CP-201000251  
Log # TXNB-10013

**SUBJECT:** COMANCHE PEAK NUCLEAR POWER PLANT, UNITS 3 AND 4  
DOCKET NUMBERS 52-034 AND 52-035  
RESPONSE TO REQUEST FOR ADDITIONAL INFORMATION REGARDING THE  
ENVIRONMENTAL REVIEW AND SUPPLEMENTAL INFORMATION FOR  
PREVIOUS ENVIRONMENTAL QUESTIONS

### **Response to Request for Additional Information Regarding the Environmental Review**

Figure 2c  
 Transmission Line Stream Crossings  
 CPNPP Site to Walnut Springs

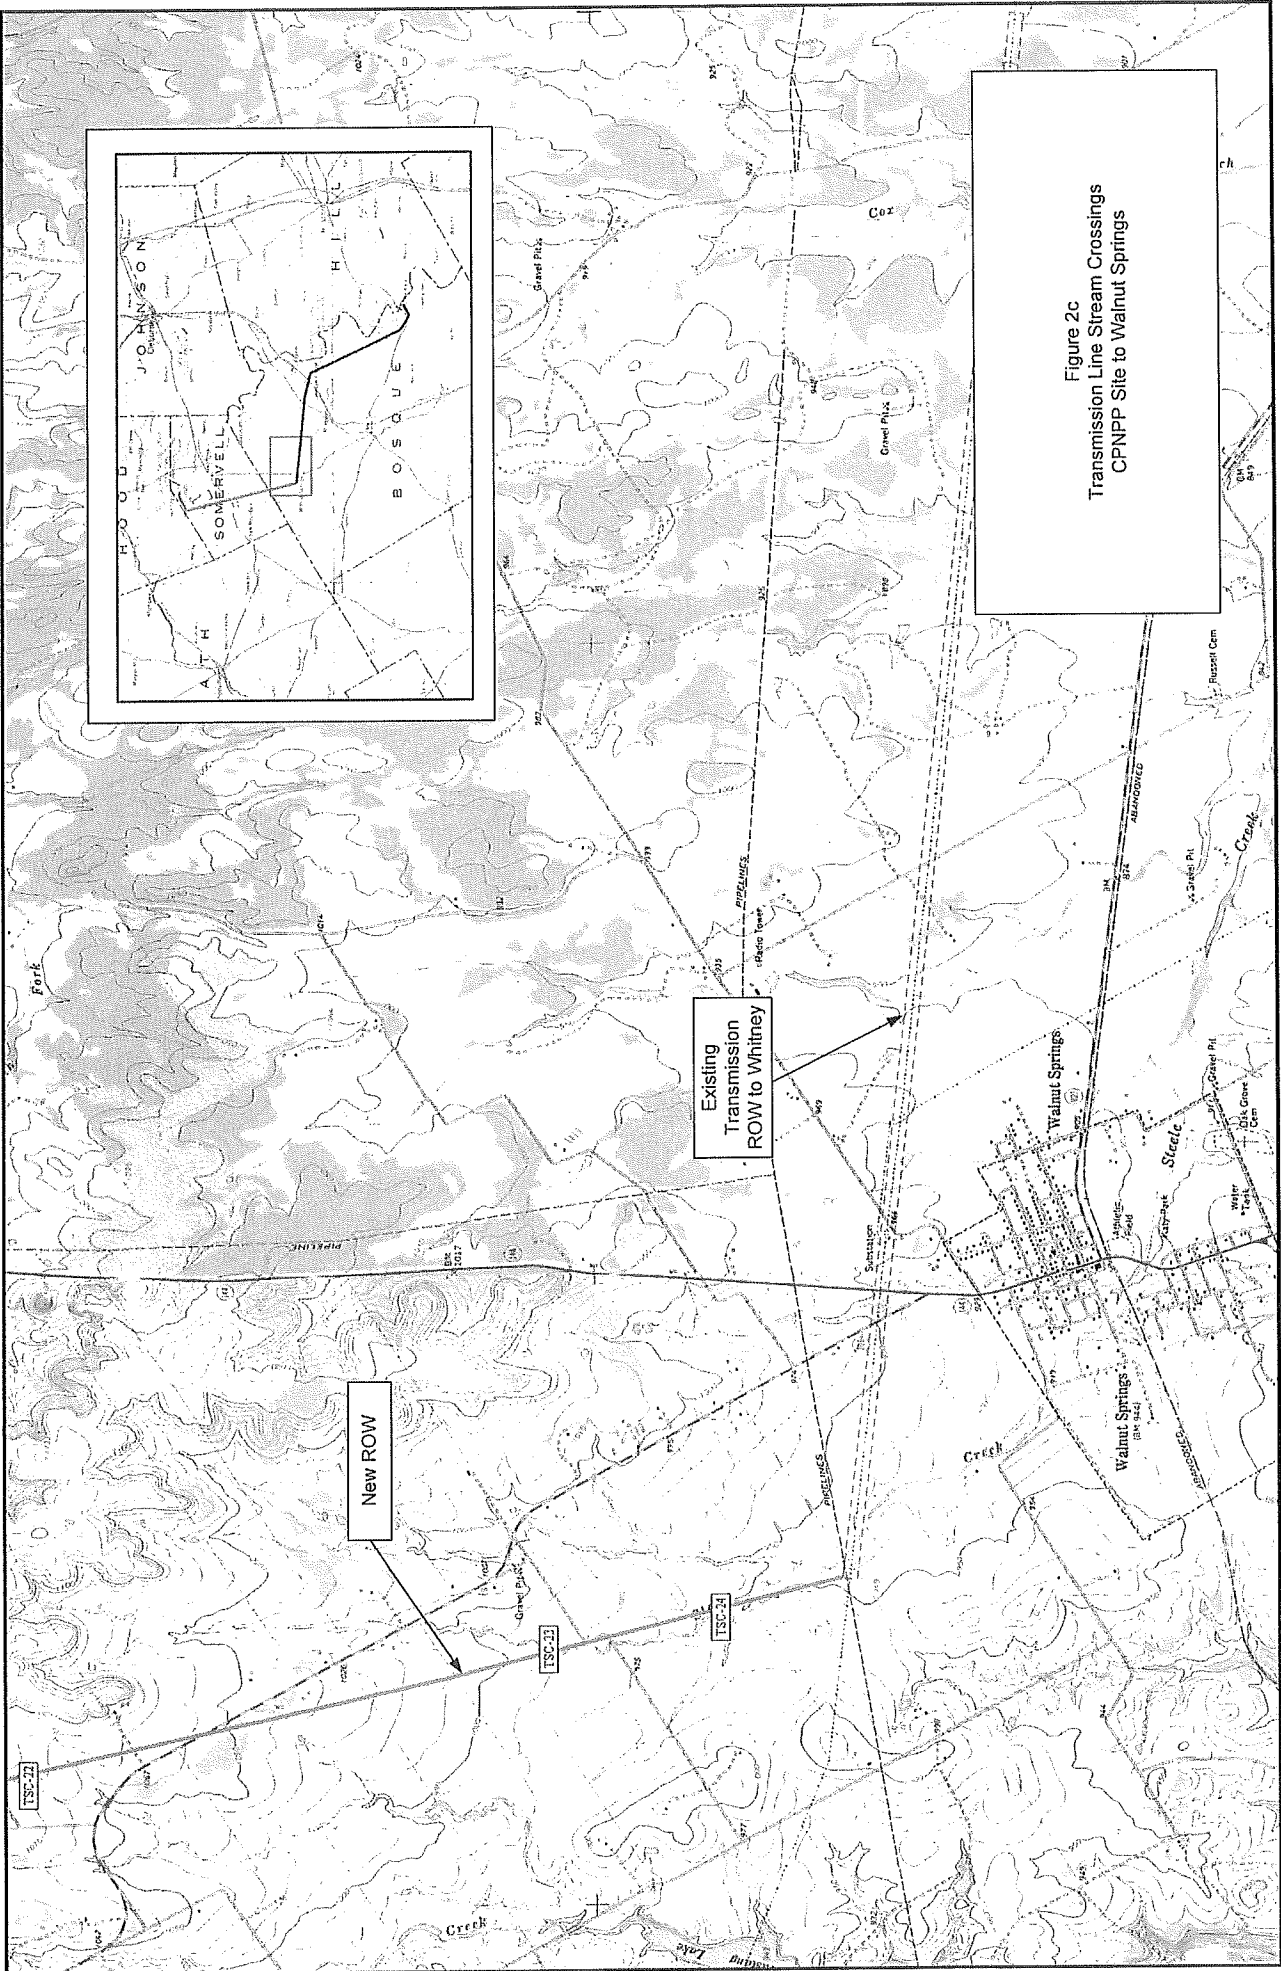
Provide descriptions of any streams that would be crossed by the proposed pipelines between Lake Granbury and CPNPP Units 3 and 4, including their ecological and hydrological characteristics. Provide an estimate of the number of linear feet of streams that would be affected by the construction of Units 3 and 4 pipelines, as well as transmission lines. These data should be provided for each right-of-way (ROW).

Additional cooling water intake and discharge pipelines are expected to be constructed for CPNPP Units 3 and 4 extending from the plant to Lake Granbury (ER Figure 1.1-4). The pipelines are expected to occupy an existing 50-ft ROW and are expected to run parallel to the existing water pipelines. Intake and discharge structures for CPNPP Units 3 and 4 are expected to be placed to the north of and adjacent to the existing Units 1 and 2 intake and discharge structures on Lake Granbury. As discussed in Subsection 2.4.1.2.2, no wetlands or habitat for threatened or endangered species are located on the pipeline ROW. Vegetation consists mainly of grassland and Ashe juniper. Land-use impacts to the ROW during construction are discussed in Subsection 4.1.2. Luminant intends to tunnel at all pipeline stream crossings to minimize or eliminate potential disturbance to streambeds and riparian areas during pipeline construction. Additionally, existing vehicular infrastructure in place at stream crossings from the construction of the existing pipeline is expected to be utilized for CPNPP Units 3 and 4 pipeline construction and maintenance. Streams encountered along the pipeline route and estimated ROW acreages at stream crossings are summarized in Table 1 and stream locations are shown on Figure 1.

Three single-circuit transmission lines are located on existing ROWs and use existing tower structures (ER Figure 1.1-5). Two double-circuit expansions require the construction of new towers on new or expanded transmission line ROW that is 160 ft wide. The first is a 45-mi line to Whitney and the second is a 17-mi line to DeCordova. No land-use impacts are anticipated from the transmission line construction activity located on existing or expanded ROWs as vegetation maintenance is already performed. Therefore, only new ROW that does not parallel an existing transmission ROW was analyzed for new impacts. Land use along the DeCordova ROW consists mainly of grassland, while the land use along the Whitney ROW consists of primarily grassland with some deciduous and evergreen forest. Updated Table 2.2-4, provided with the response to Question GEN-08, shows the land-use acreages in transmission line ROW.

Figure 3.4-1 Simplified Water Use Diagram

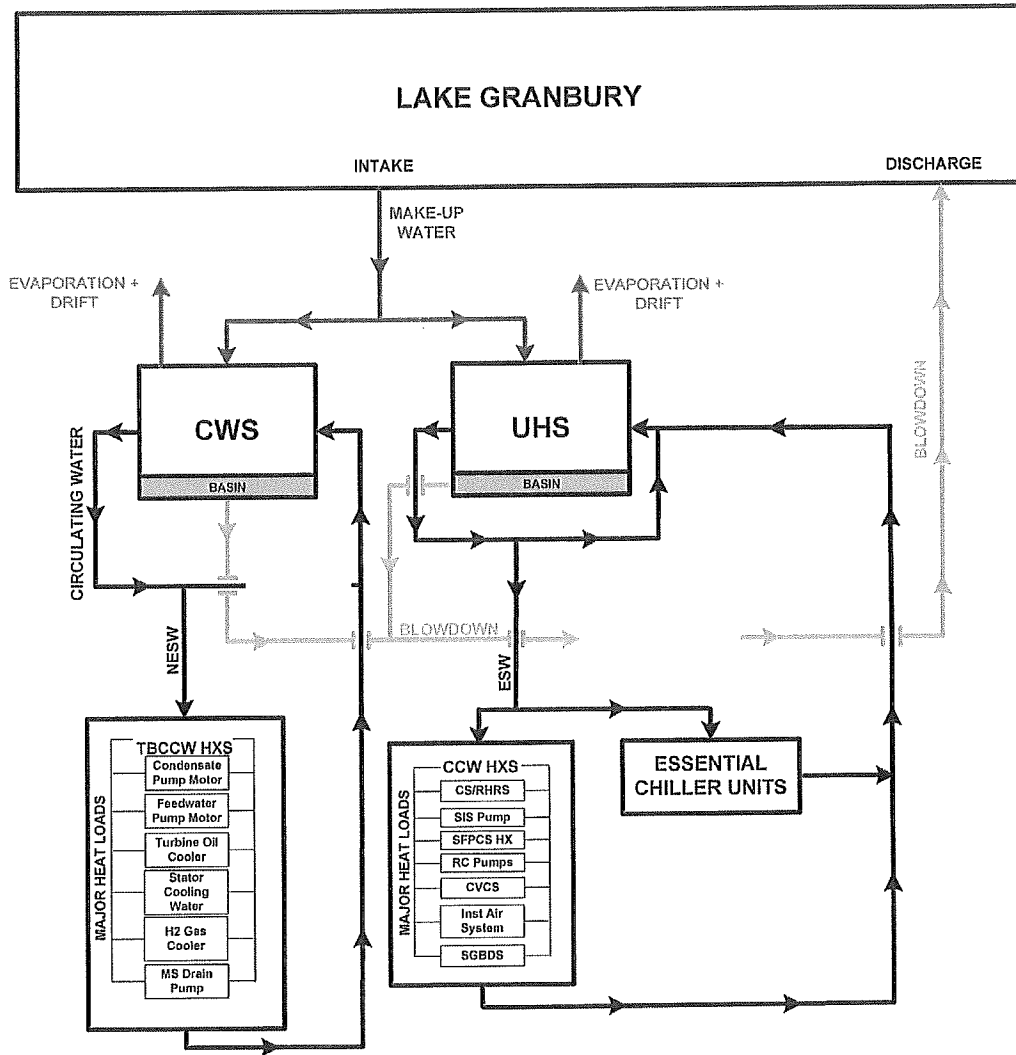
Provide an updated version of ER figure 3.4-1 which shows a schematic representation of the proposed Comanche Peak Nuclear Power Plant (CPNPP) cooling system water use during normal operation. Specifically, the figure should include:

It is unclear whether the ultimate heat sink (UHS) and circulating water system (CWS) share the same cooling towers and basins. Clarify the flow of water from the CWS and UHS to the cooling tower(s) and basin(s). If the UHS cooling towers are separate from the CWS cooling towers, revise figure 3.1-1, as well, to show the location of the UHS cooling towers.

Figure 3.1-1 has been revised to include an additional item in the legend (Item 45 UHS COOLING SYSTEM / ESW PUMP HOUSE) to indicate the location of the UHS cooling towers and the ESW pump house which are separate from the CWS cooling towers.

Figure 3.3-1 has been updated to include the BDTF. The cooling tower designations have been changed to be consistent with revised Figure 3.4-1. The supporting table (pages 2 & 3) has been revised to indicate single unit and two-unit flows; duration and flow; users/discharges associated with Unit 3 and 4 construction activities.

**Figure 1.1-5 Electrical Transmission Corridors**

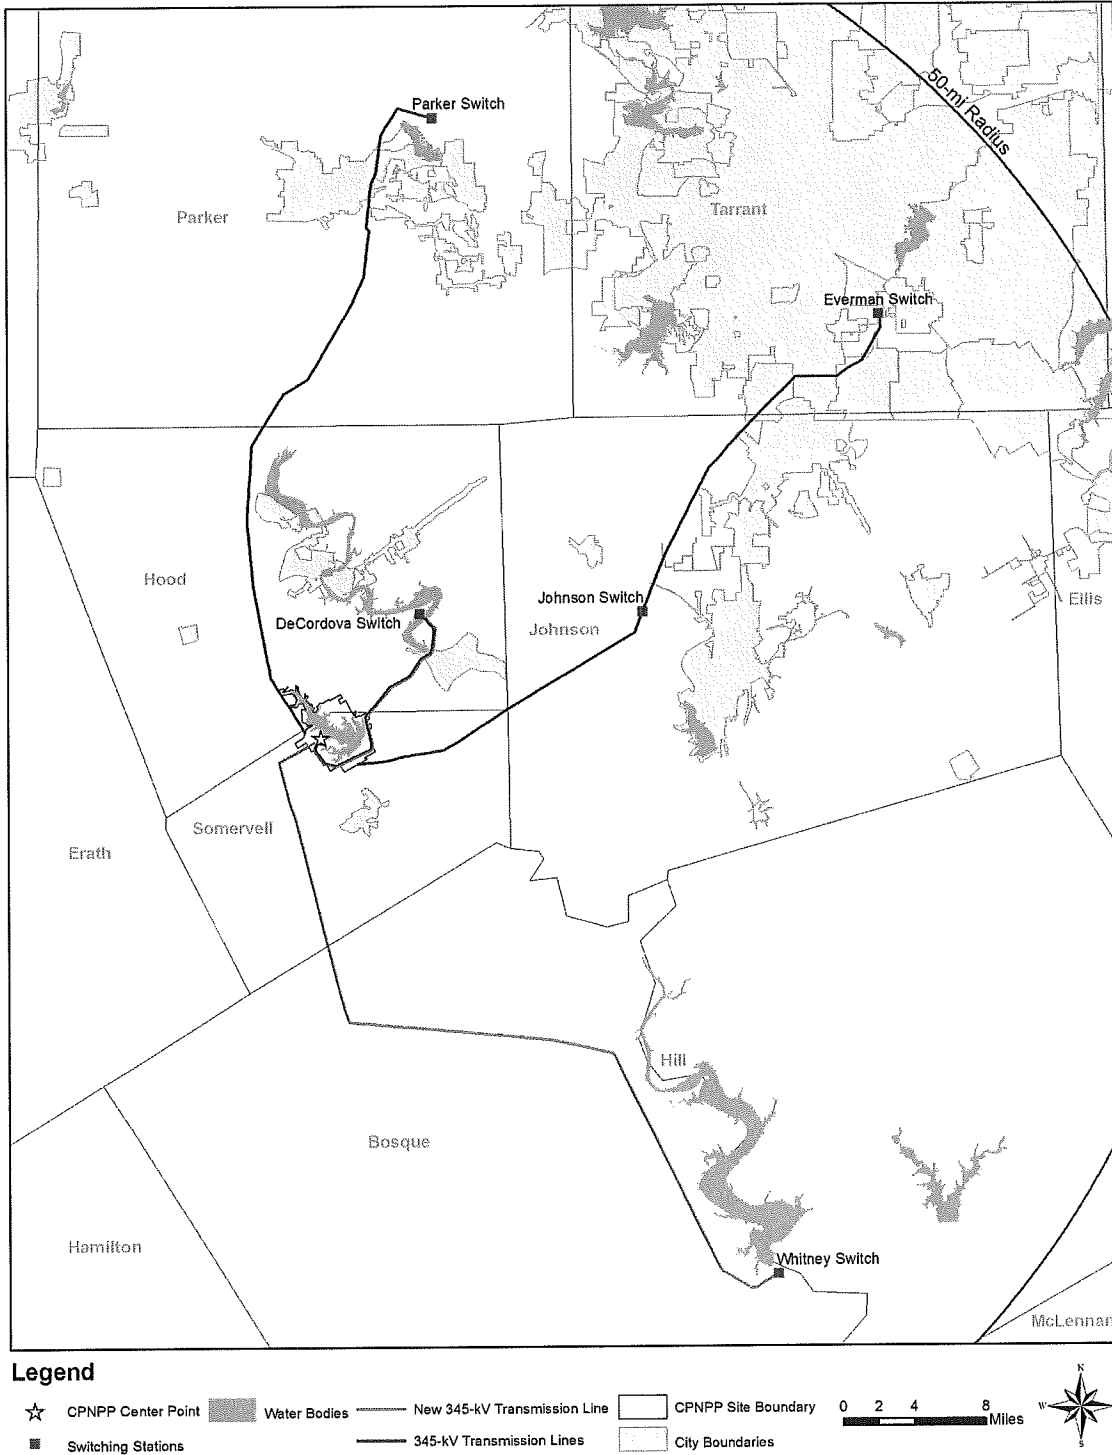
- Describe the route/alignment and cumulative width of the existing 185-kV and 345-kV DeCordova rights-of way (ROWs).
- Figure 1.1-5 and 3.7-4 indicate that the proposed ROW would either be adjacent to the existing ROWs or it would be built along a completely new ROW. Describe the cumulative width (i.e., the combined width of the three ROWs) and route/alignment if the new transmission line were built adjacent to the current ROWs.
- Provide an explanation and environmental implications for the differences between the MVA rating of the DeCordova circuit and other transmission line circuit MVA rating.

The existing DeCordova transmission lines have a 230-ft ROW and their alignment is illustrated on ER Figures 3.7-4 and 1.1-5. The proposed line is anticipated to run adjacent to the existing lines, adding an additional ROW of 160 ft. This creates a cumulative ROW of 390 ft. The ER text, tables and figures have been revised.

See attached marked-up ER Revision 1 pages 2.2-5, 2.2-13, 4.1-5 and Figure 1.1-5.

Figure 9.2.4-2R Potable and Sanitary Water System Flow Diagram (Sheet 2 of 2)

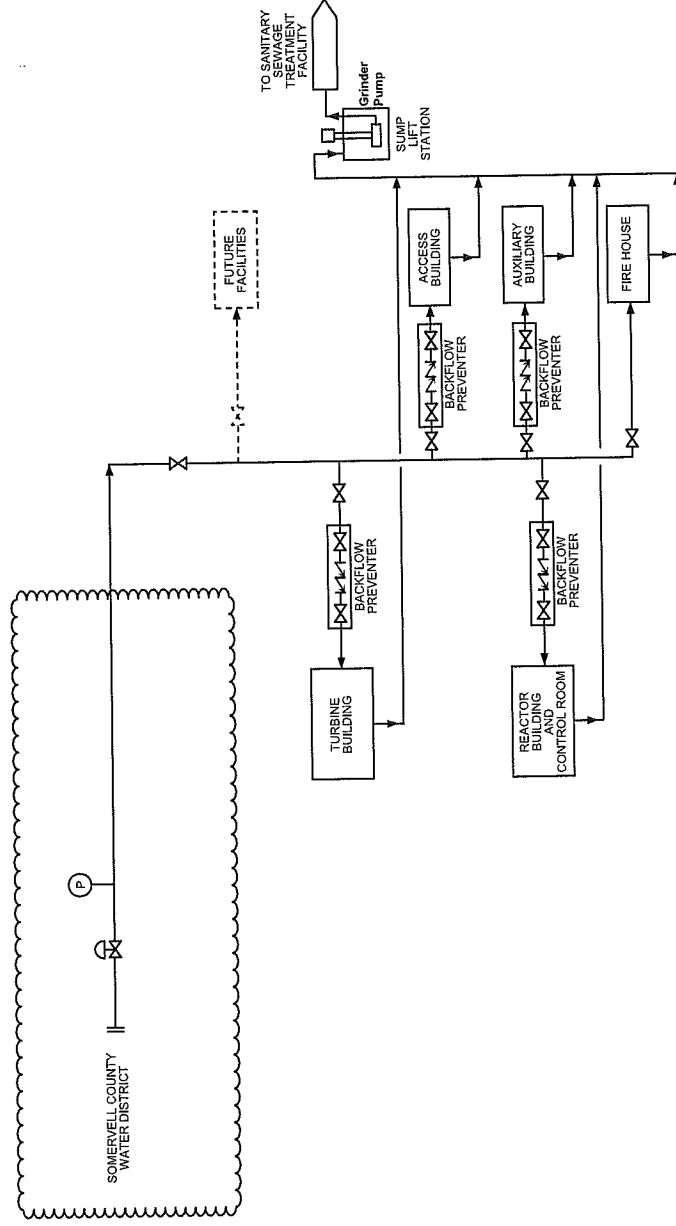
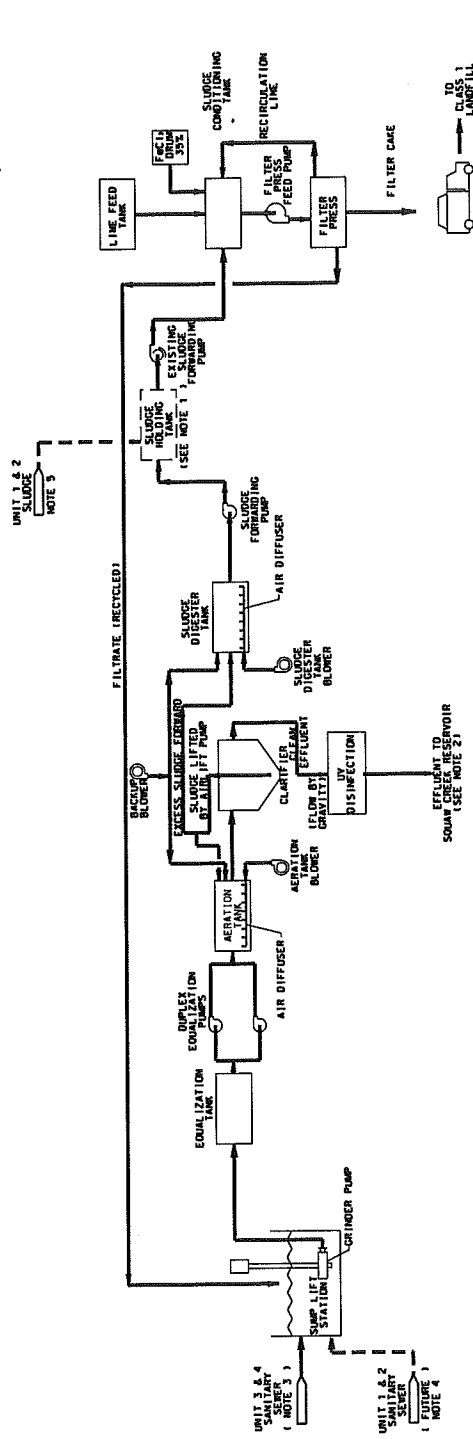
Provide a detailed explanation of the proposed sanitary wastewater system with a diagram illustrating the connections between the components, and explain the connections with the system for Units 1 and 2 and how it will be utilized.

A process flow diagram of the sanitary wastewater treatment system with additional detail and clarification has been added to the FSAR as Figure 9.2.4-2R, which supplements FSAR as Figure 9.2.4-1R.

A new sanitary waste treatment plant will be installed as part of the Unit 3 and 4 construction project. The new system will include a filter press for sludge dewatering. Unit 1 and 2 sludge is presently dewatered using a bag filter system. The Unit 1 and 2 bag filter system will be decommissioned and replaced by the new Unit 3 and 4 filter press, which will have sufficient capacity to dewater sanitary waste sludge from all four units. During Unit 3 and 4 construction, the existing Unit 1 and 2 system will operate in parallel with the new treatment system since neither system alone will have sufficient capacity to treat the waste generated during construction. After completion of Unit 3 and 4 construction, the Unit 1 and 2 sanitary waste treatment system will be decommissioned and the combined sanitary waste from Units 1 – 4 will be treated by the new system.
